## STM32MP131x/3x/5x device errata

This document applies to the part numbers of STM32MP131x/3x/5x devices and the device variants as stated in this page. It gives a summary and a description of the device errata, with respect to the device datasheet and reference manual RM0475. Deviation of the real device behavior from the intended device behavior is considered to be a device limitation. Deviation of the description in the reference manual or the datasheet from the intended device behavior is considered to be a documentation erratum. The term “errata” applies both to limitations and documentation errata.

**Figure 1. External SMPS connection**

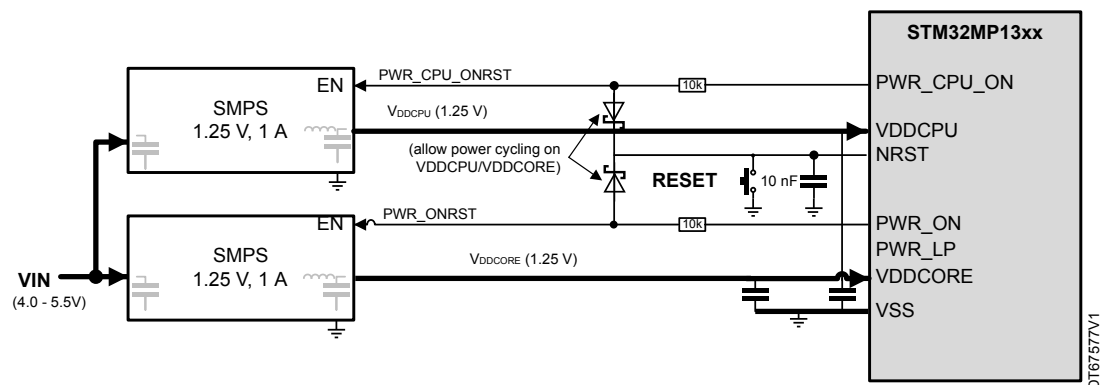
The activation of NRST (by external signal, internal watchdog or software) may not properly reset the glitch-free clock switches inside the RCC.

As a consequence, the peripheral kernel clock previously used by the application remains selected. If not enabled again (by default or by software), there is no kernel clock present on the related peripheral and the BootROM hangs.

1. **By hardware**, ensure that the  $V_{DDCORE}$  and  $V_{DDCPU}$  logic is reset on NRST activation:
  - With STPMIC1  
By default, a power cycle on  $V_{DDCORE}$  and  $V_{DDCPU}$  (and  $V_{DD}$ ) occurs upon activating NRST.
  - Without STPMIC1  
Connect the POWER\_CPU\_ON and PWR\_ON signals to the external SMPS enable inputs as illustrated next.

Activating NRST then causes the  $V_{DDCPU}$  and  $V_{DDCORE}$  supply voltages to cycle.

**Figure 2. Synchronous multiplexed NOR/PSRAM read timings**

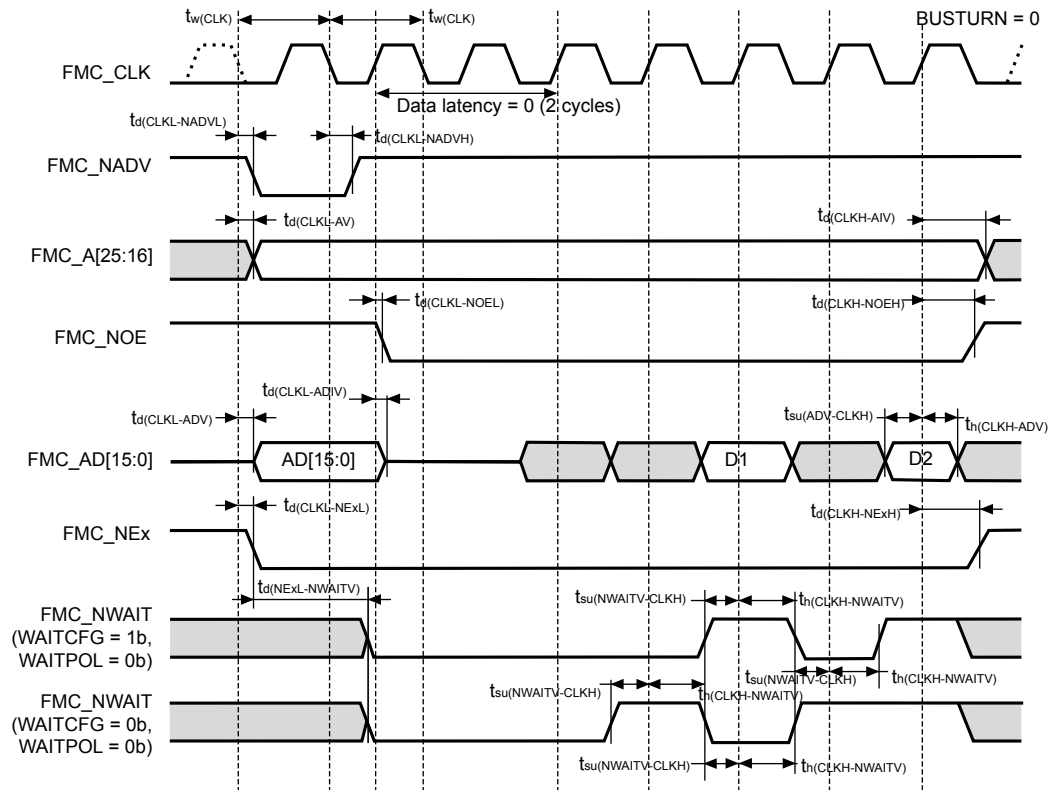
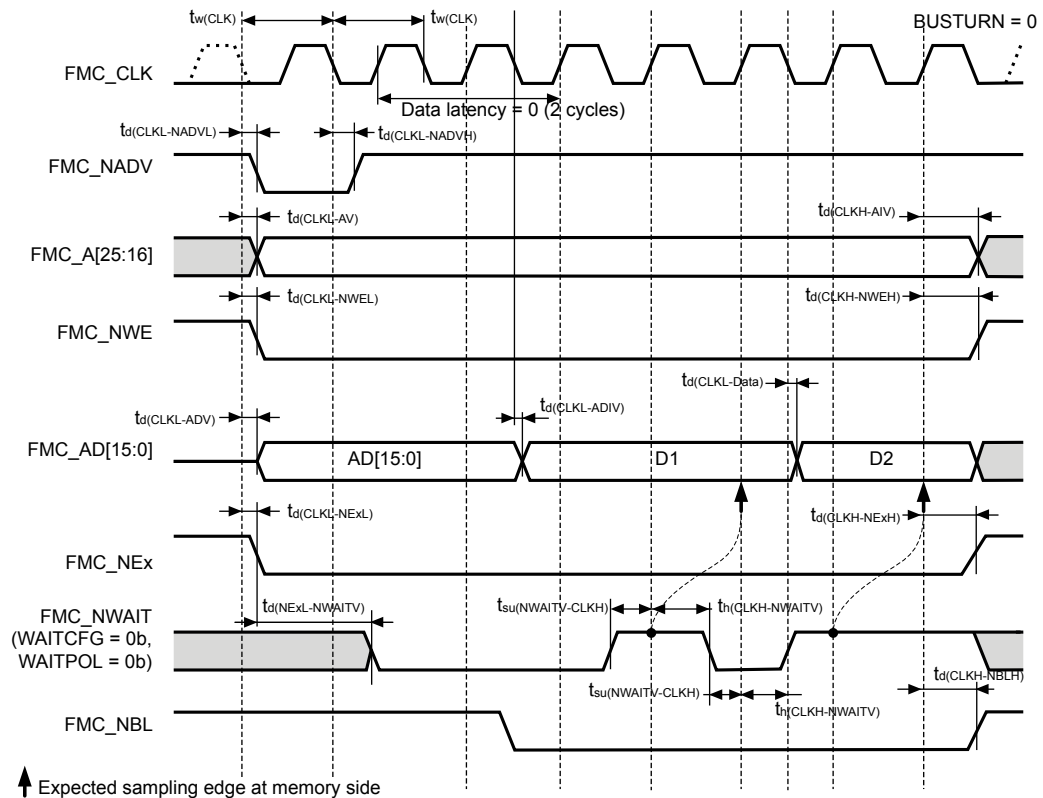
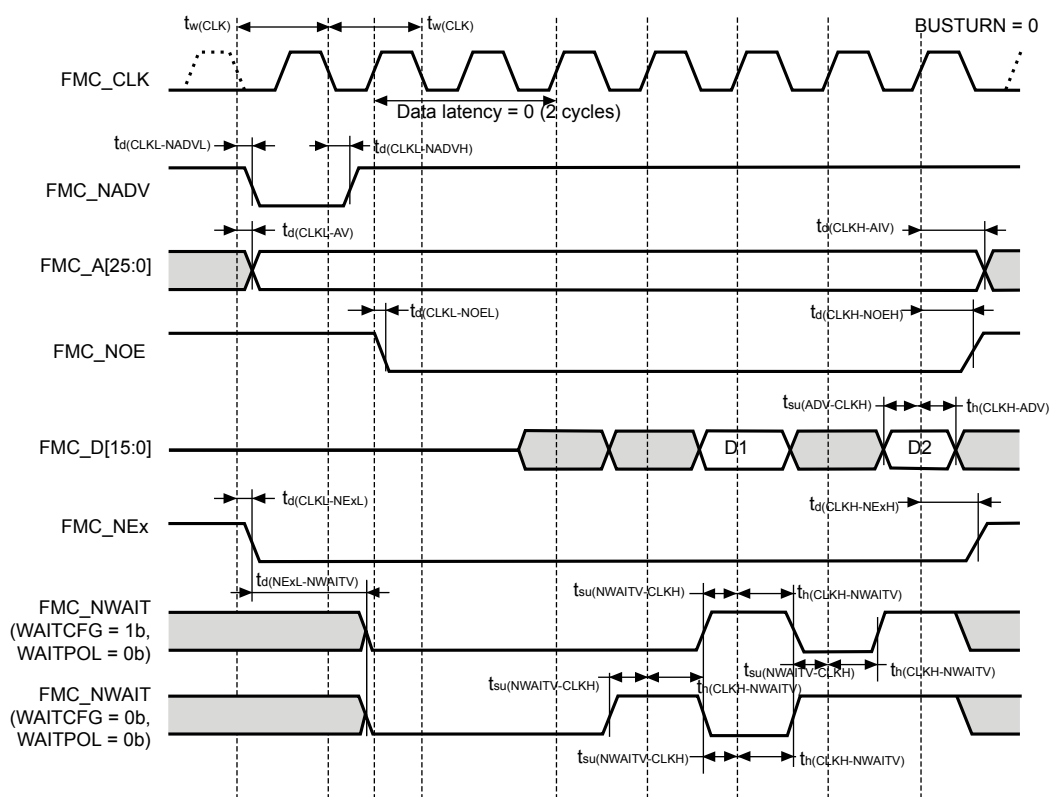
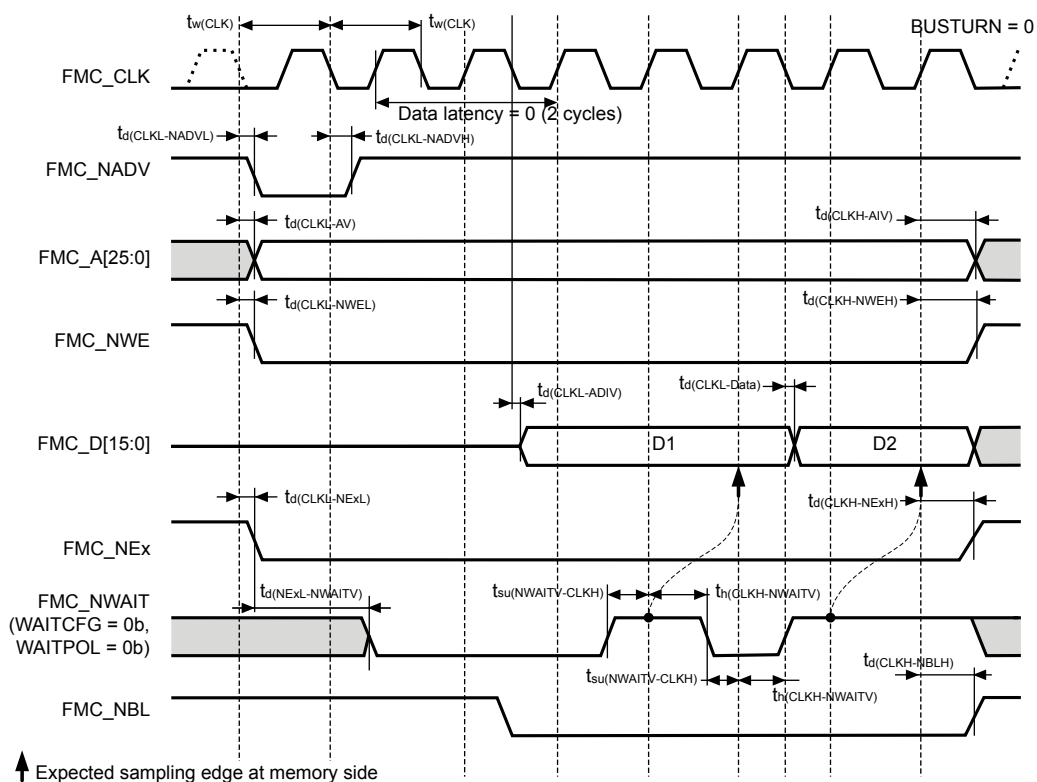
FMC\_NWAIT input should be active before a specific timing delay (with respect to FMC\_NE falling edge) to be considered by the FMC sequencer for correct wait state(s) insertion above the fixed DATLAT setting. This delay value is missing in the product datasheet.

This delay is specified as  $t_{d(NEXL-NWAITV)}$  in the following diagrams with the max value below:

Symbol	Parameter	Min	Max	Unit
$t_{d(NEXL-NWAITV)}$	FMC_NEx low to FMC_NWAIT valid (x = 0..2)	-	$((DATLAT + 2.5) \times t_{w(CLK)}) - 4$	ns

$t_{d(NEXL-NWAITV)}$  max timing should be fulfilled whenever NWAIT is used.

The following figures should be used for released datasheets where the  $t_{d(NEXL-NWAITV)}$  is not present.

**Figure 9. Example of PWM output mode**

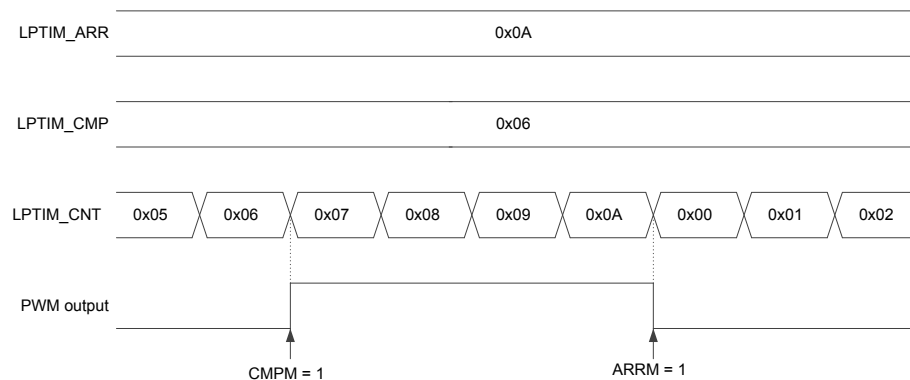
Consequently, it is not possible to generate PWM with a duty cycle of 0% or 100%.

The following waveform gives the example of PWM output mode and the effect of the delay:
